Project Name: Pearl Fire Stations

Project Number: 22-099 & 22-108

ADDENDUM NO. 03

1 PARTIAL FOUNDATION PLAN - CENTRAL STATION ENCLOSURES
1/8" = 1'-0"

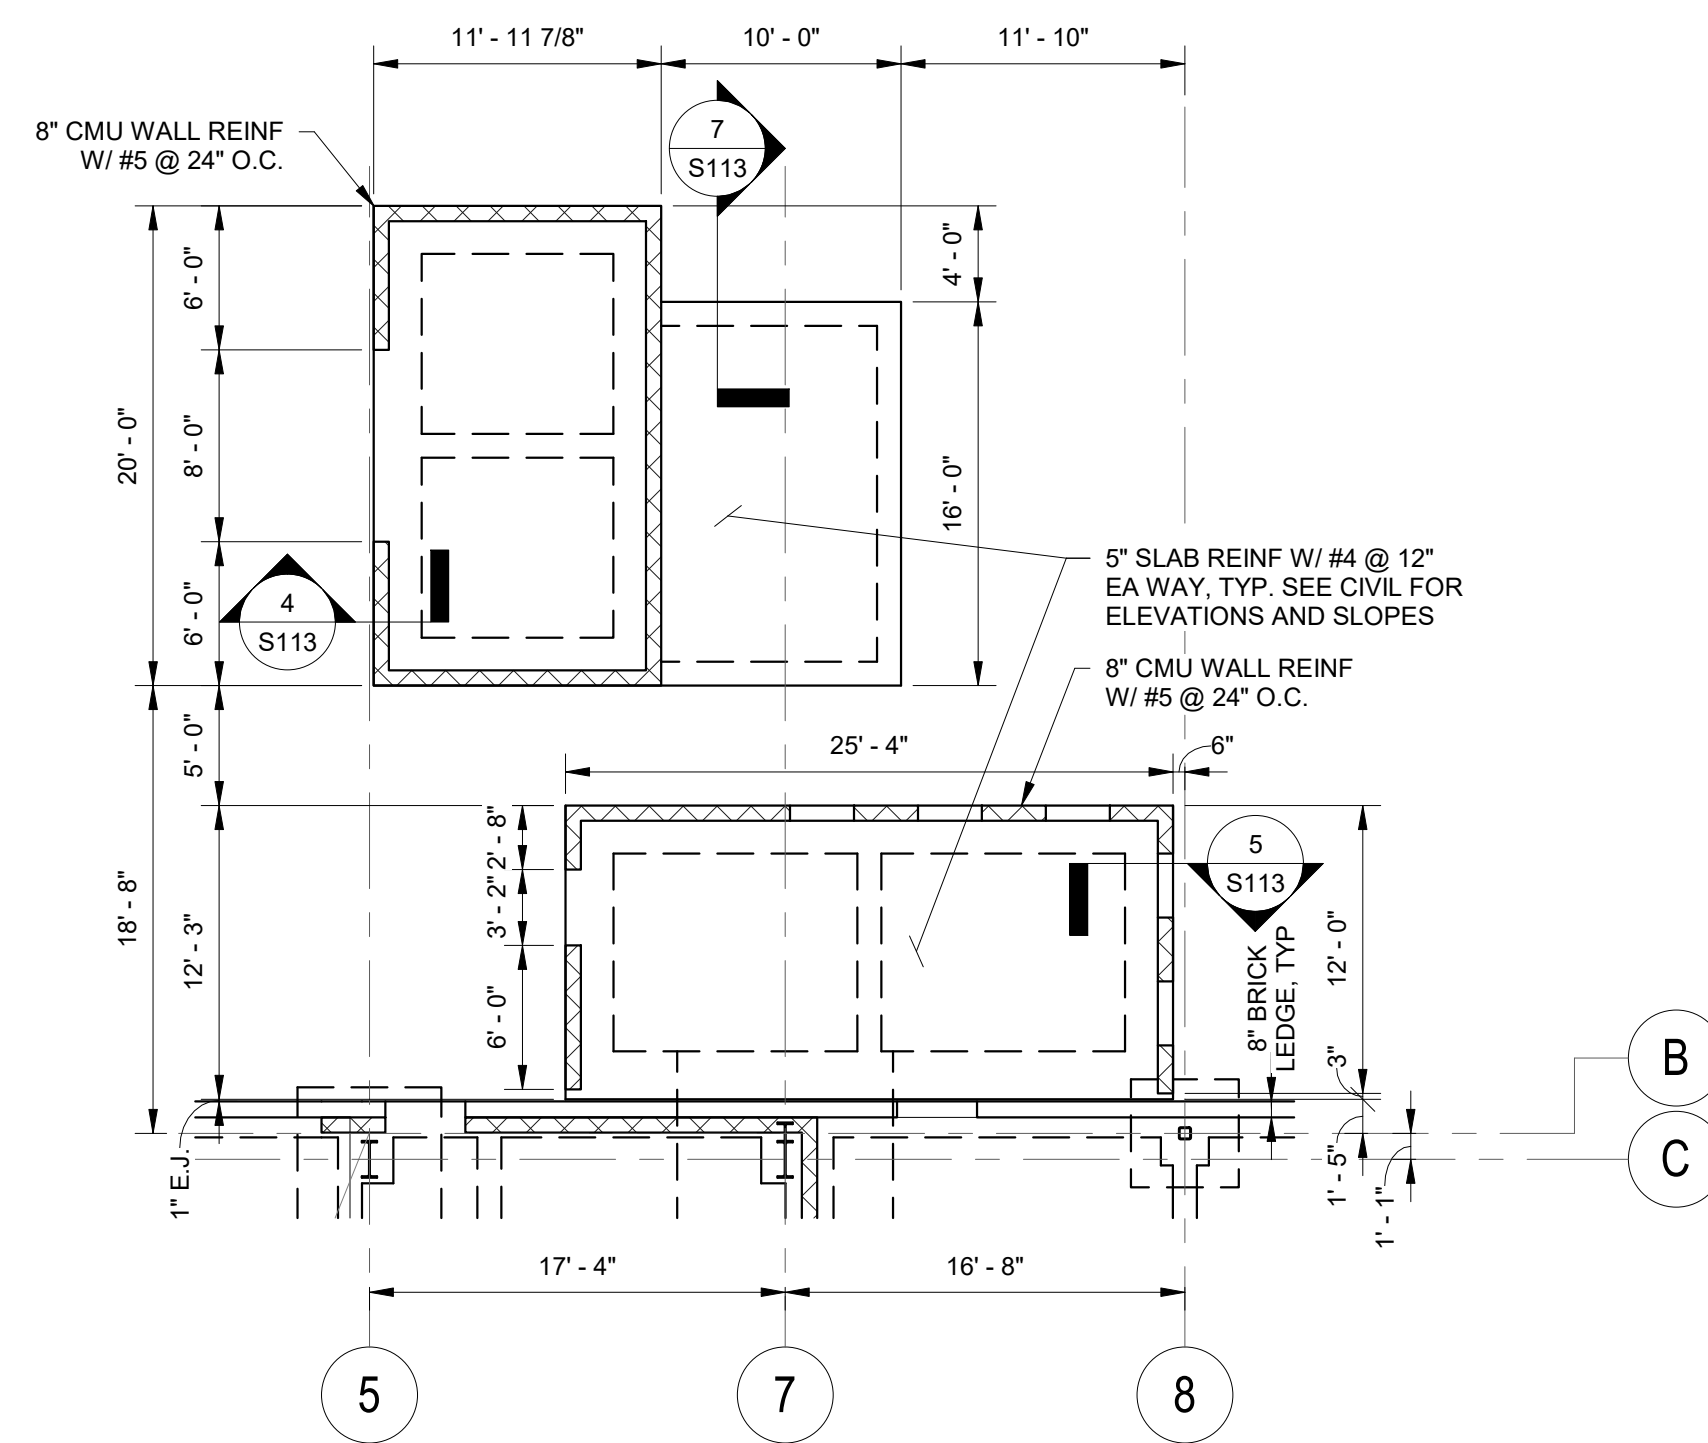
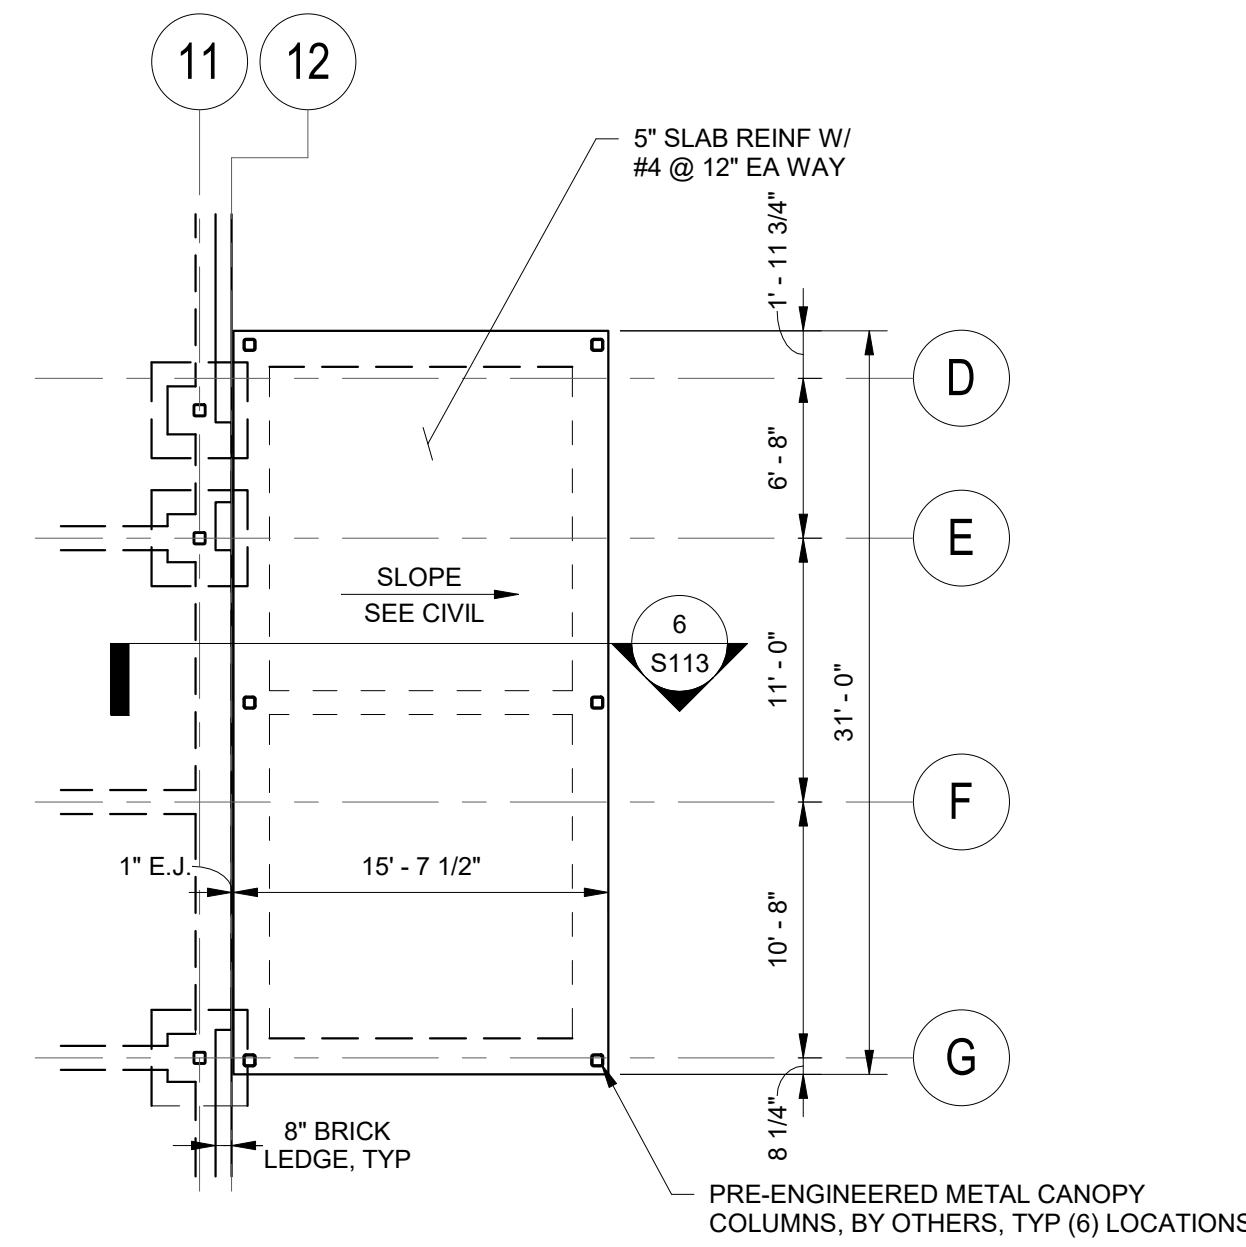
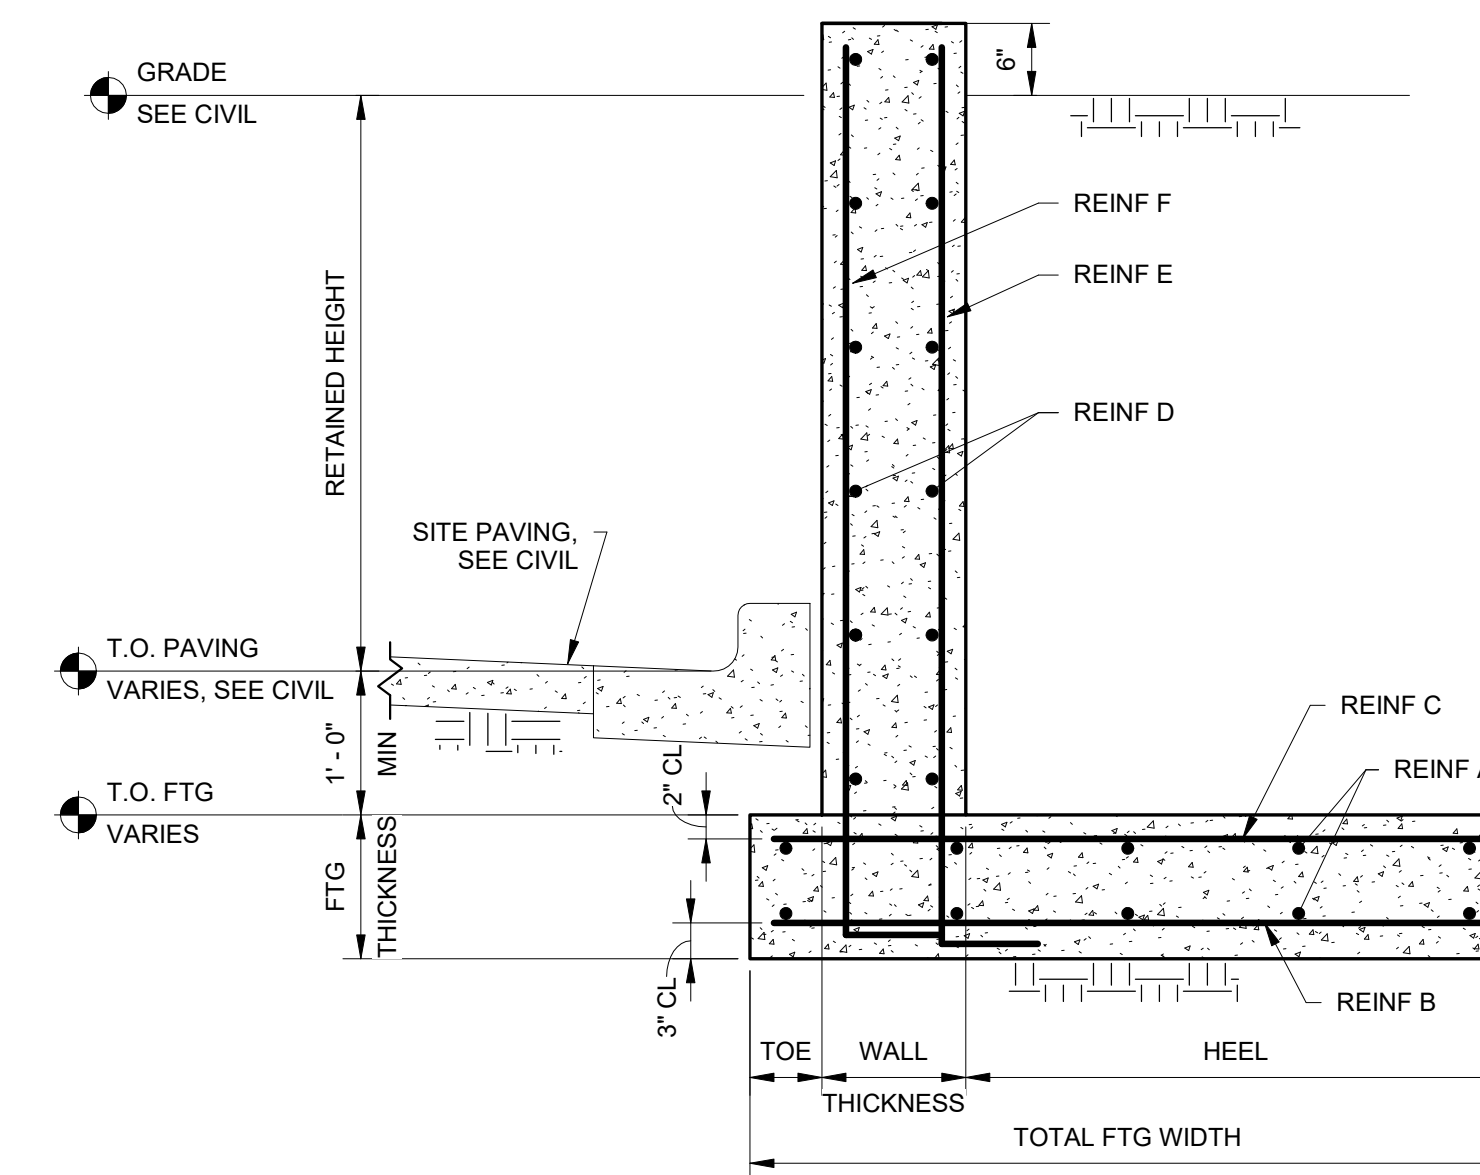
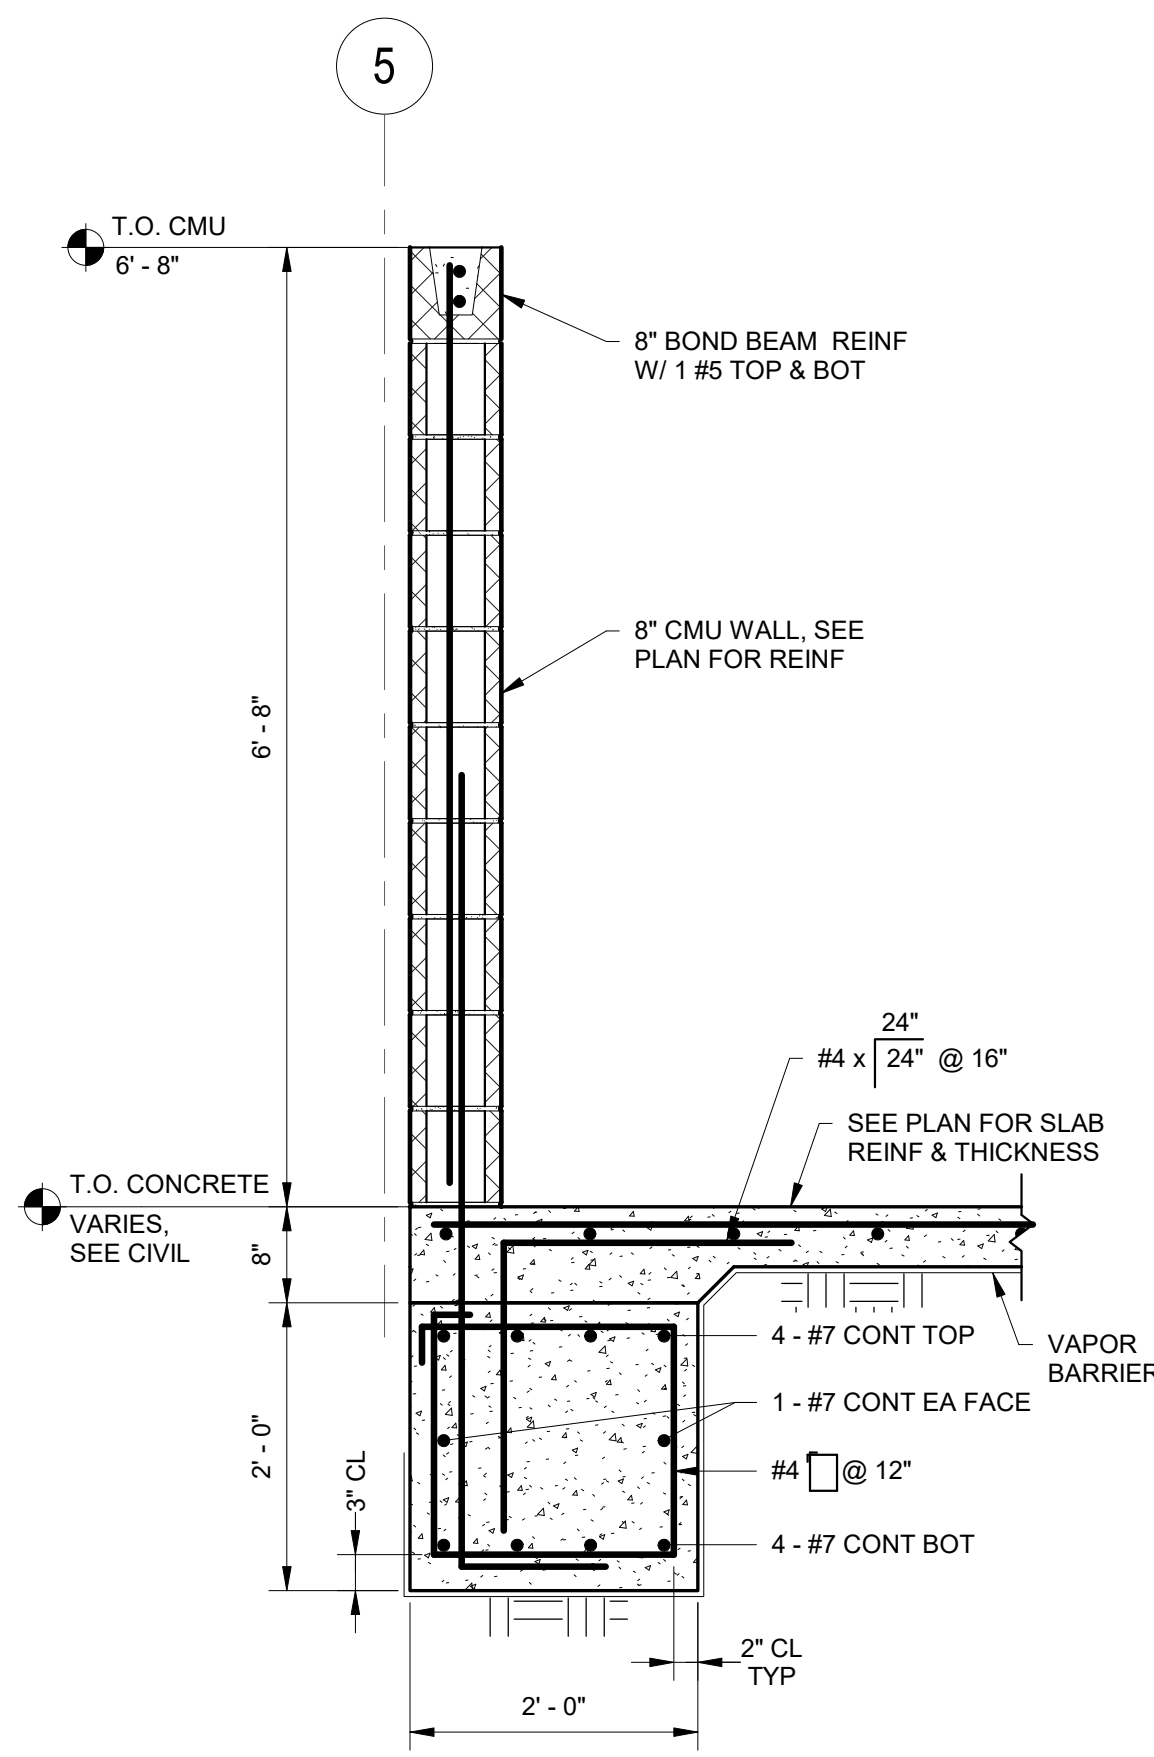
- ITEM NO. 11 **S113 Partial Foundation Plan - Central Station**
ADD Sheet S0113 in its entirety.
Clarification: New sheet S113 provides foundation and slab information for trash enclosure and generator slab at Central Fire Station. Sheet also includes retaining wall information.

8	The site plans show a retaining wall on Sheet C210 and says See Structural and there is nothing in the structural about a retaining wall. Also the Arch and Civil Drawing show Dumpster Enclosures and there is no details for the foundations or the walls. Please provide	23-Aug-23	Cecil Mason, Flagstar Construction	Addendum 2 (issued 9/1/23) included detailed information about the Dumpster Enclosures and Mechanical Yard Enclosures. Addendum 3 includes the requested structural information.
9	The 2 canopies for the alternates you do not show any detail for them either. Is there a slab under them or what???	23-Aug-23	Cecil Mason, Flagstar Construction	Post-supported canopies are specified via Section 10.7315, updated via Addendum 3. Slab details are included in Addendum 3 structural updates.
10	Spec section 26.43.00-1.1.A Calls for a Surge Protective Device, but this is not shown on the drawings. Please advise if this is needed and where to locate them for each station.	7-Sep-23	Alvin Willey, Thrash Commercial Contractors, Inc.	Provide a Type 2A SPD in the main panel of each building.
